Factory Service Bulletin

SUBJECT: MEMORYMOOGS (ALL SERIAL NUMBERS) BULLETIN: 843
MONO/TRANSPOSE/HOLD C.V. MODIFICATION

DATE: April 10, 1984

CONTOUR GLIDE
BOARD #3

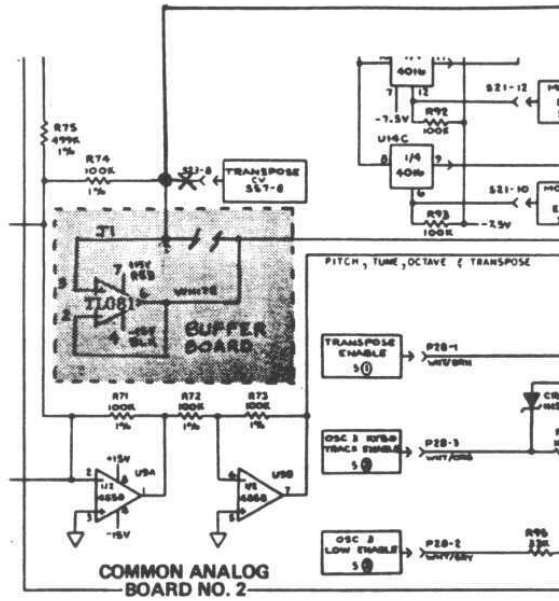
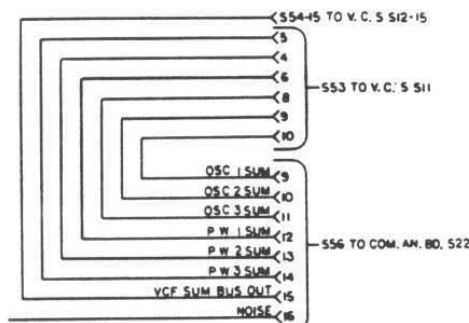
CAUSE: Flux contamination on: The CONTOUR/GLIDE board near U10 or on the DMUX board near connectors S57 or S58.

VERIFICATION: Place the unit in any polyphonic preset (MONO button OFF) and insure the HOLD button is OFF. On the COMMON ANALOG board #2, measure the D.C. voltage on the front (keyboard) side of R74 (100K 1%). R74 is the 5th resistor to the right of the red MTA connector P24. The measured voltage must be 0 Volts +/- .02 Volts. If an offset voltage greater than this exists, follow the procedure below:

- SOLUTION:
- 1) On the CONTOUR/GLIDE board #3, remove U10 (4016) and bend Pin 3 out parallel to the body of the IC and reinsert it in the socket.
 - 2) Carefully tin the end of U10 Pin 3 using a grounded soldering iron.
 - 3) On the COMMON ANALOG board #2, tin the front end of R74. Cut the trace on the component side of the board between S23 pin 8 and the J1 jumper wire.
 - 4) Tin both ends of a 15" (380mm) insulated jumper wire.
 - 5) Tack-solder one end of the jumper wire to the front end of R74.
 - 6) Route the wire over the rear end of the COMMON ANALOG board, then run it under the board to the CONTOUR/GLIDE board.
 - 7) On the CONTOUR/GLIDE board, tack-solder the free end of the jumper wire to Pin 3 of U10.
